**Subject:** RE: Mansfield #11 (NCS1913741281) and Salty Dog (NCS1916853082)

I have reviewed the Remediation plan for the Mansfield #11 incident nCS1913741281 and have approved it with the following conditions of Approval

RE: Revised Remediation Work Plan Hilcorp Energy Company

> Mansfield #11 – NCS1913741281 San Juan County, New Mexico

Figure 1: Biopiling Area

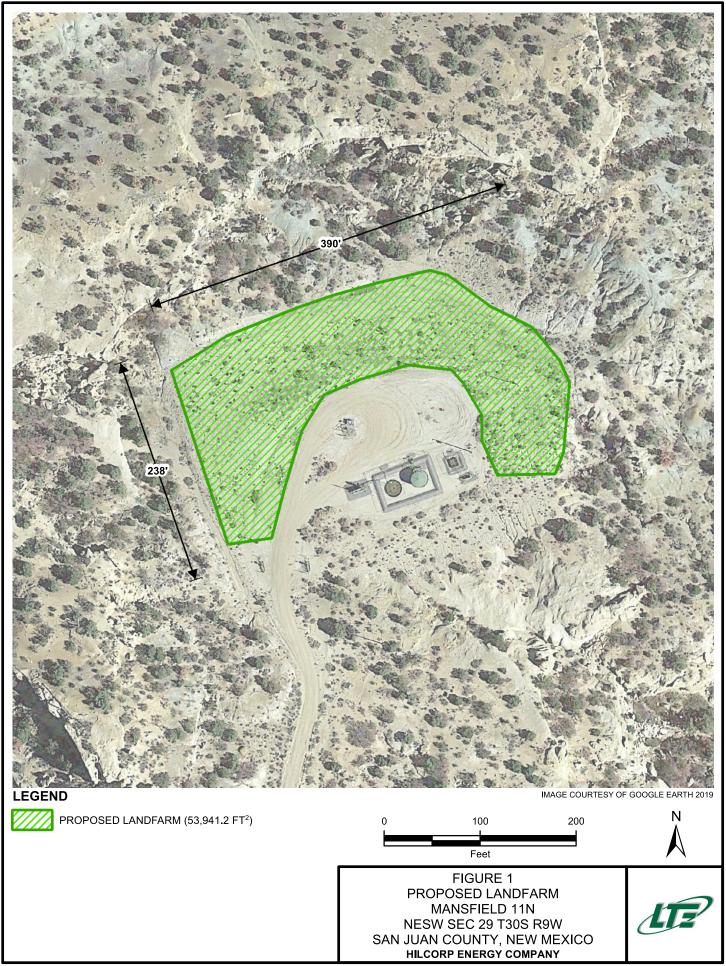
- HEC must submit and get approval of a small Land farm permit pursuant to 19.15.36.16 NMAC and follow all applicable requirements.
- Once a small Land Farm permit is approved HEC will send notification of the approval to the Division District Office via email notifying of the approval.
- HEC vadose zone sampling request does not meet the requirement of part 36 and is denied
- During remediation HEC must maintain site security(fencing) and an egress at the open excavation to ensure the protection of fresh water, human health and the environment.
   If HEC chooses to back fill the excavation prior to completion of land farmed remediation this requirement is null.
- A full closure report for the excavation is due no later than July 15, 2022

The basis of this approval is that this landform will be onsite for an extended period of time and needs to be approved by the land owner. If you have any additional questions please give me a call.
